Sewer Basis of Design Report

PRELIMINARY Basis of Design Report

The Clayton on Earll

3-ZN-2024

FIGURE 2

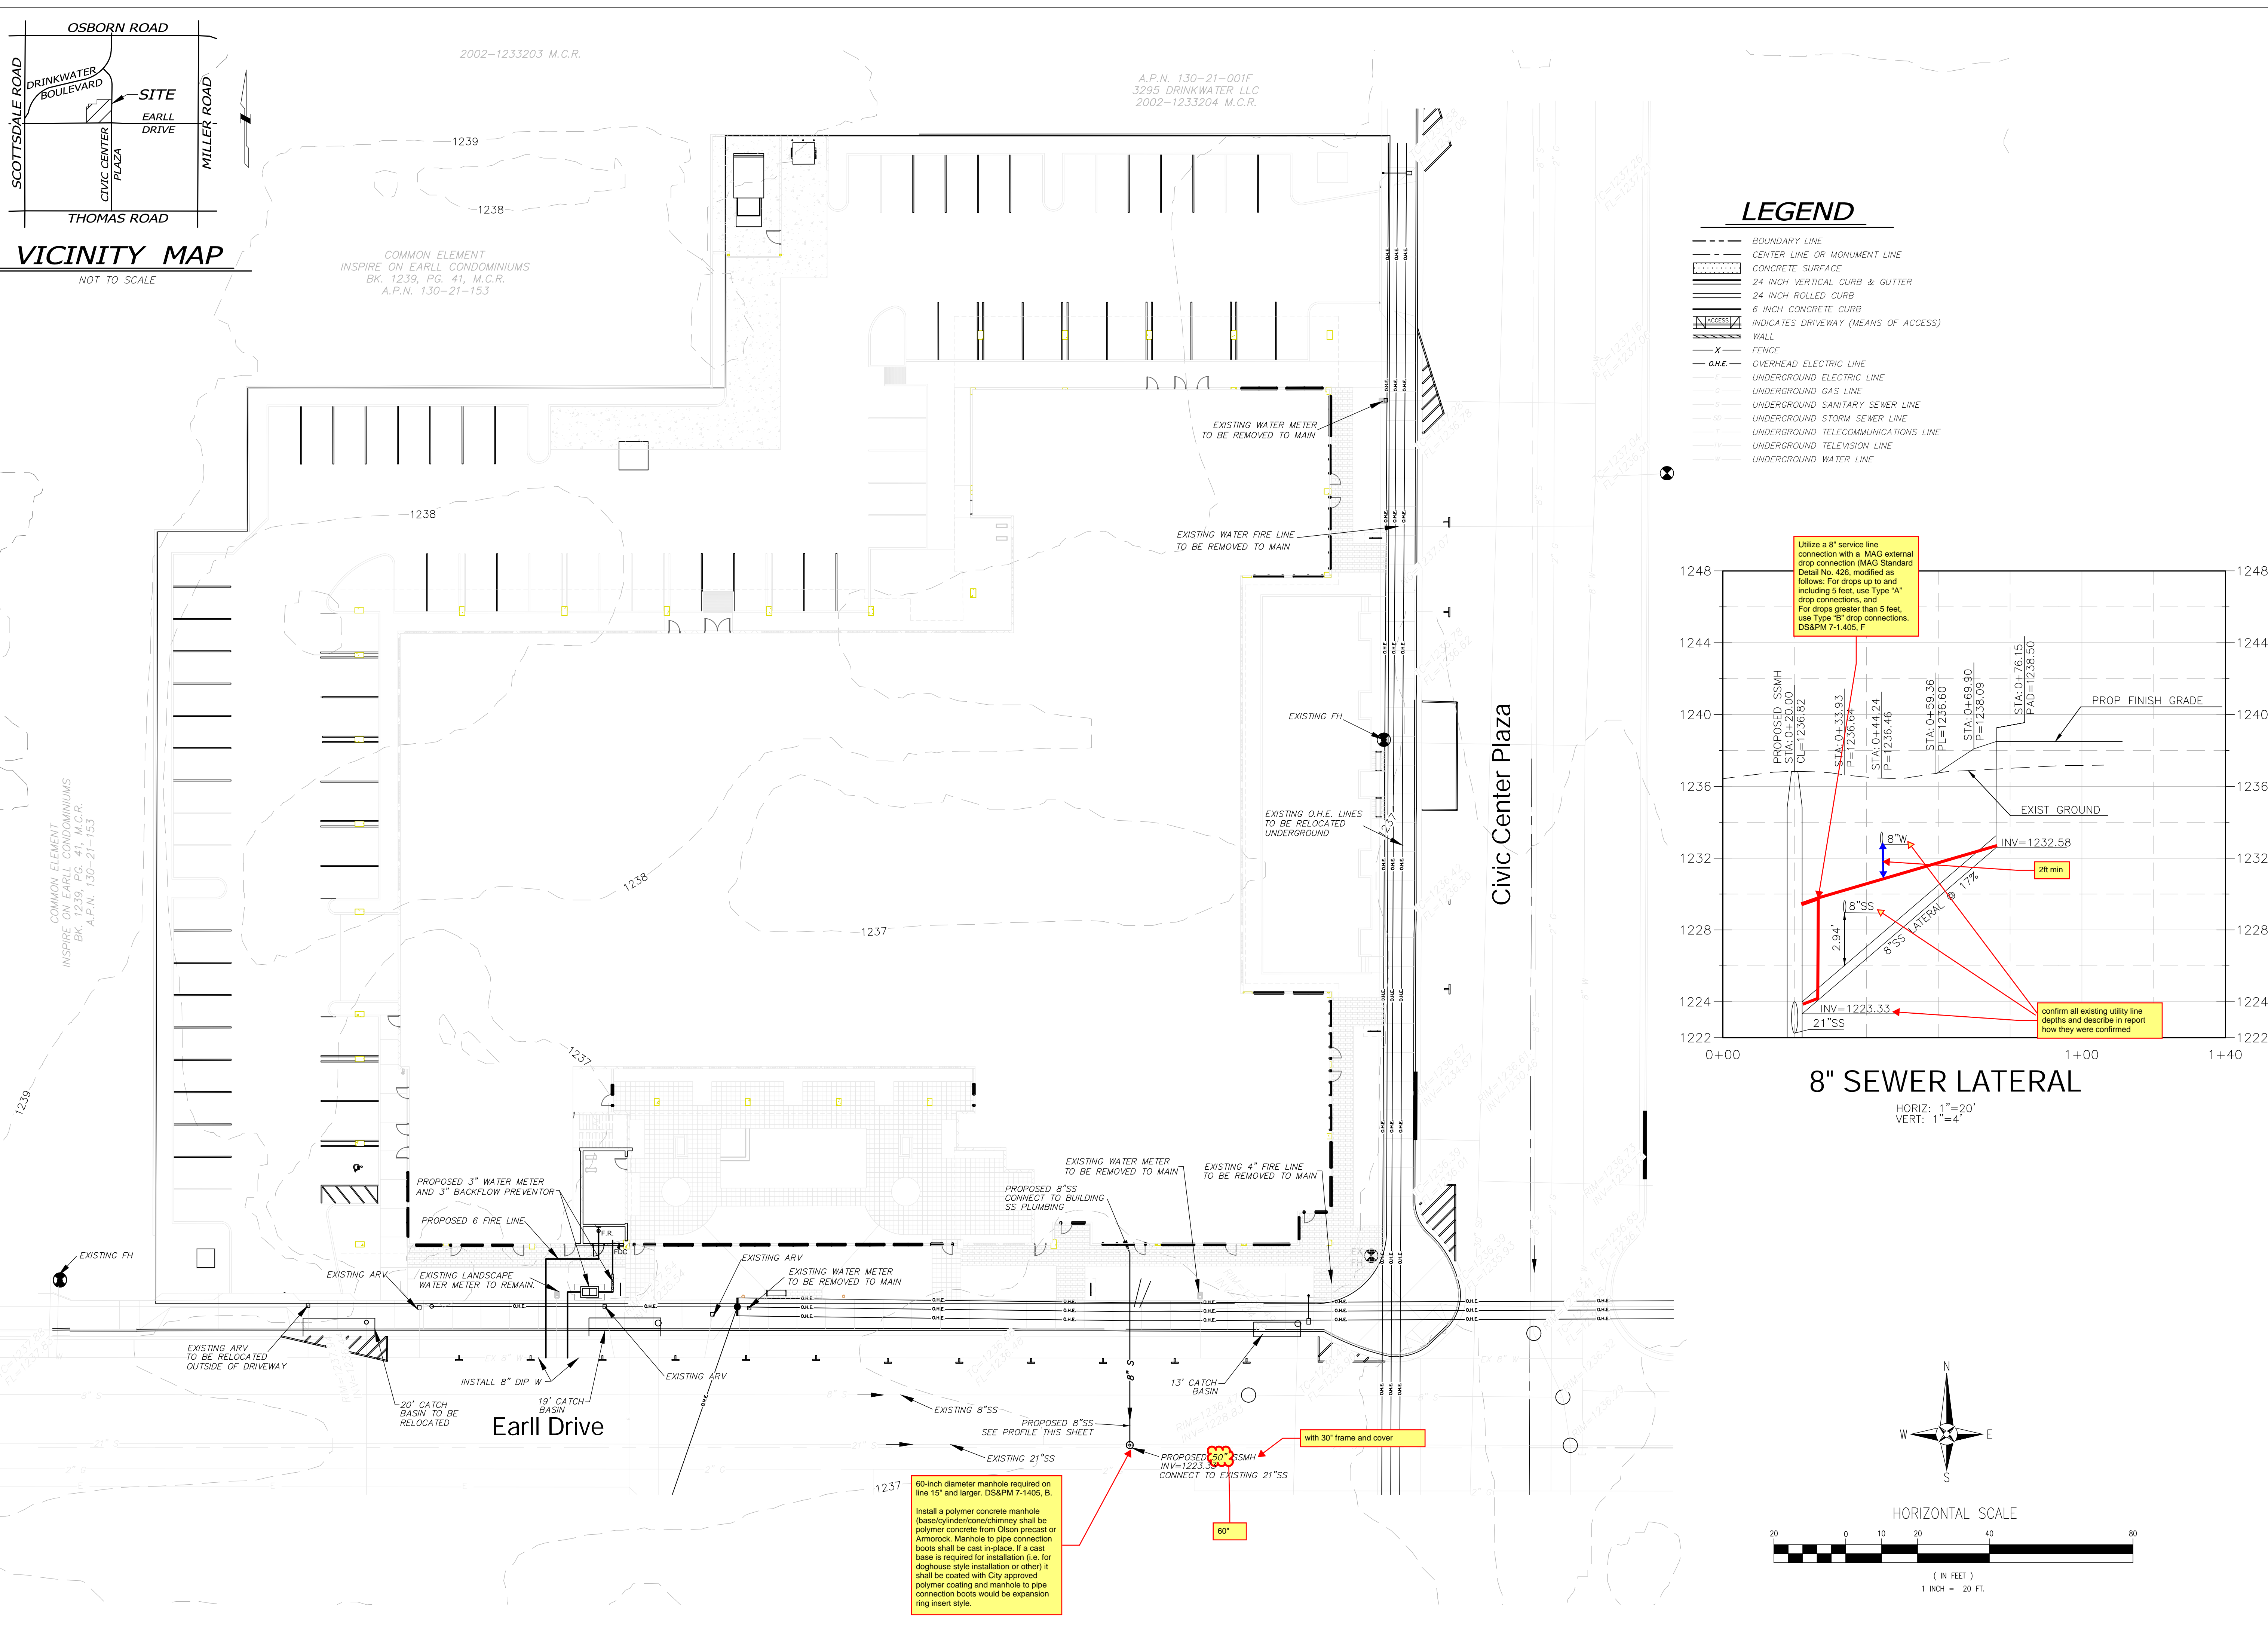
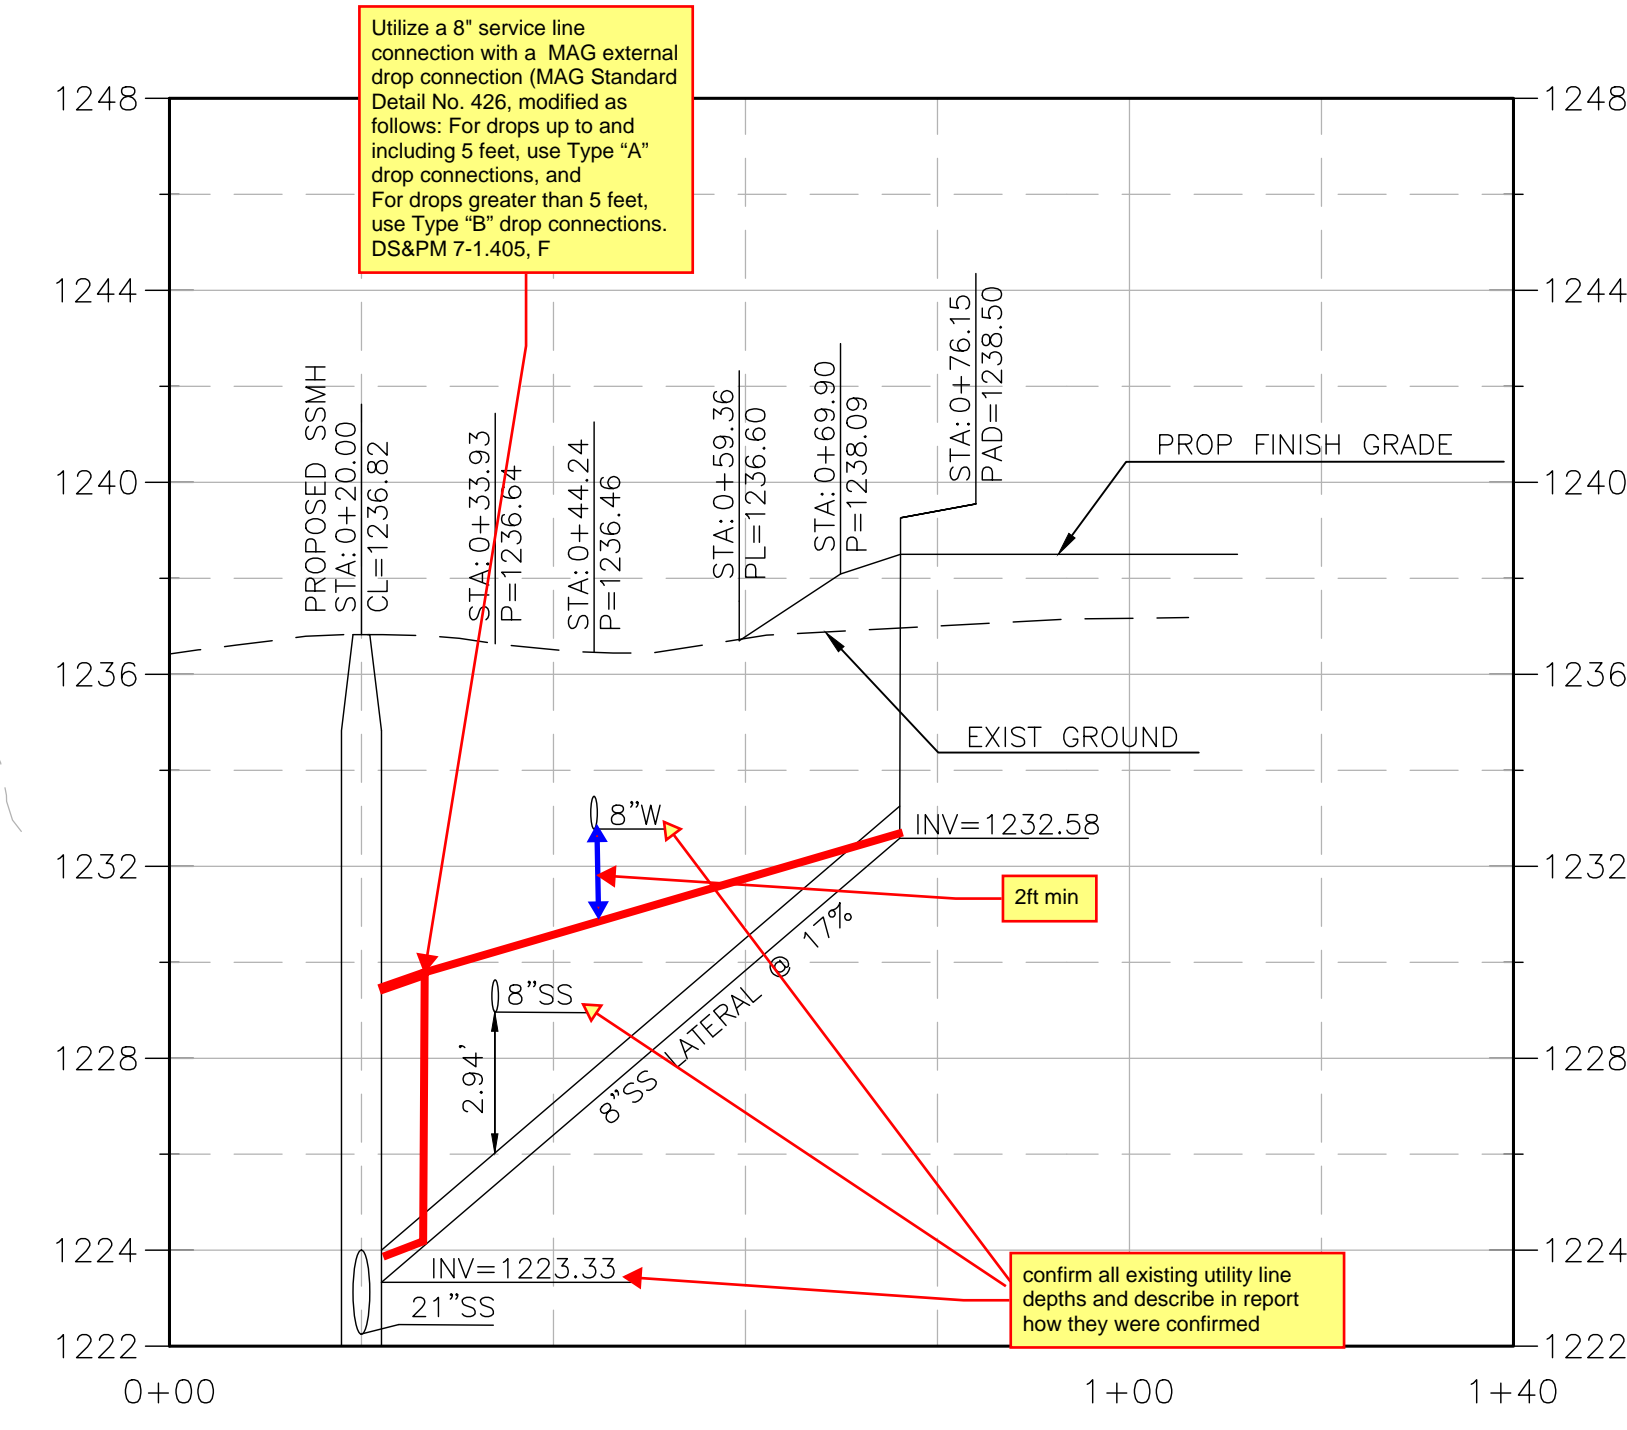
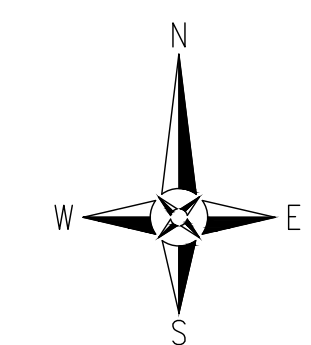
8" SEWER LATERAL

60-inch diameter manhole required on line 15' and larger. DS&PM 7-1405, B.
Install a polymer concrete manhole (base/cylinder/corner/chimney shall be polymer concrete from Olson precast or Armorok. Manhole to pipe connection boots shall be cast in-place. If a cast base is required for installation (i.e. for doghouse style installation or other) it shall be coated with City approved polymer coating and manhole to pipe connection boots would be expansion ring insert style.

21 inch pipe proposed flow hydraulics

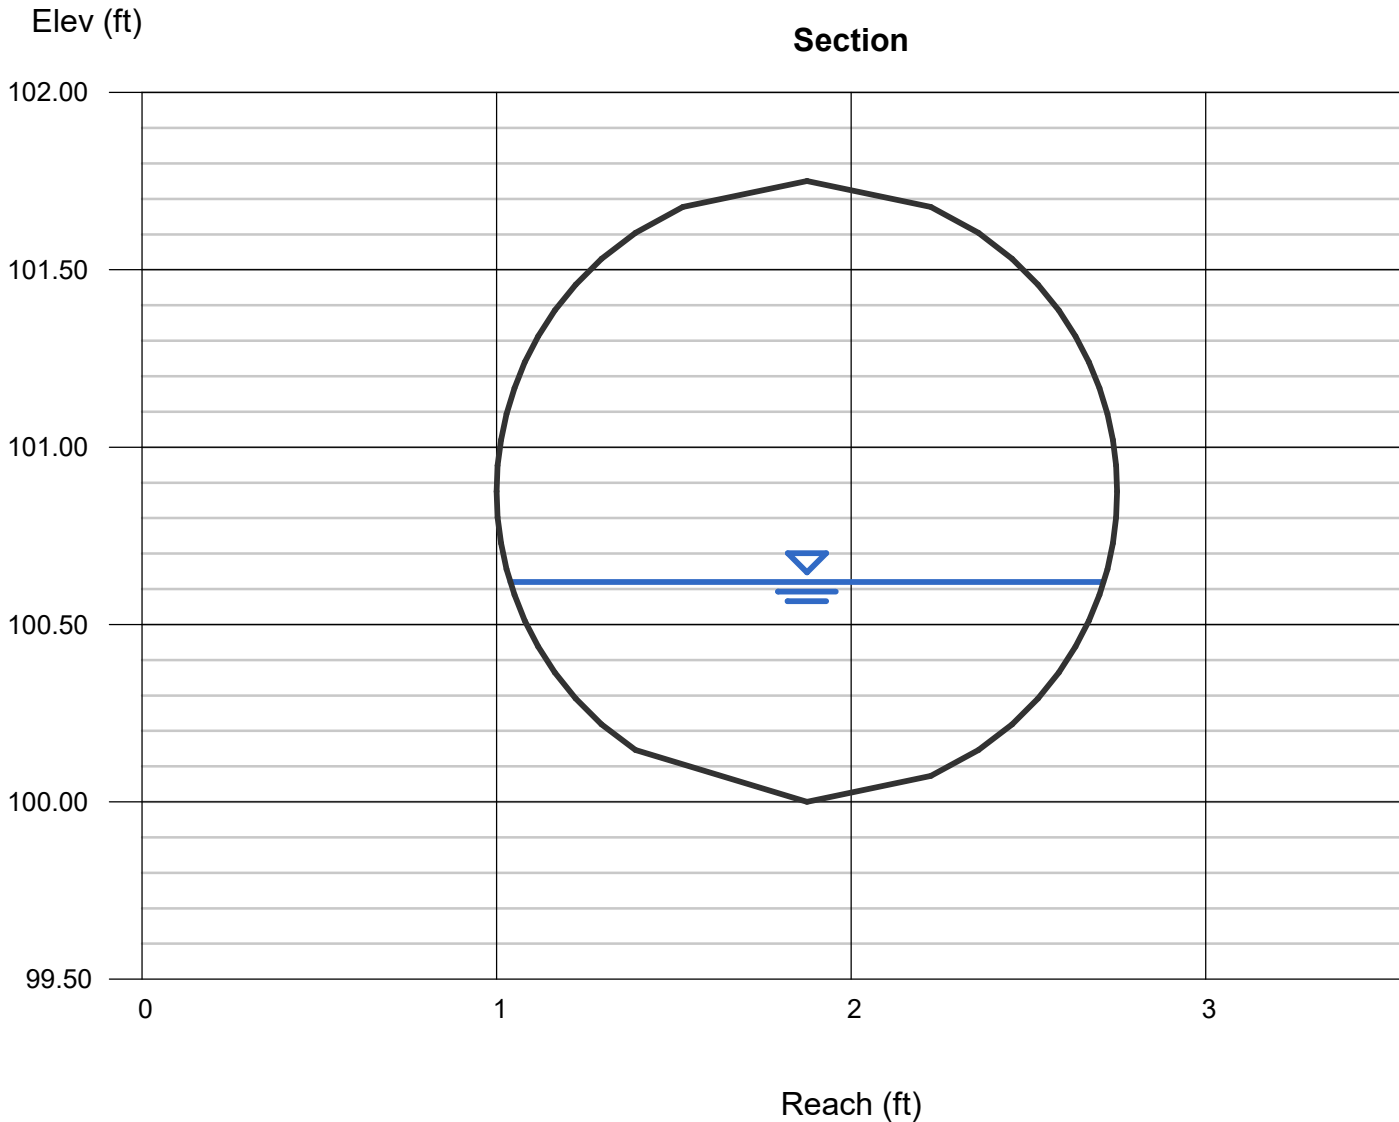
It's safer to assume a min slope in the entire length of the 21" interceptor is something around 0.002 ft/ft (3fps at d/D=1). (Note: Absolute City min slope for 21" is 0.0015 ft/ft i.e. 2.5fps at d/D=1.0) Based on this more conservative slope/capacity assumption the depth would be 9-inches at velocity of 2.76fps. This is still acceptable. OK.
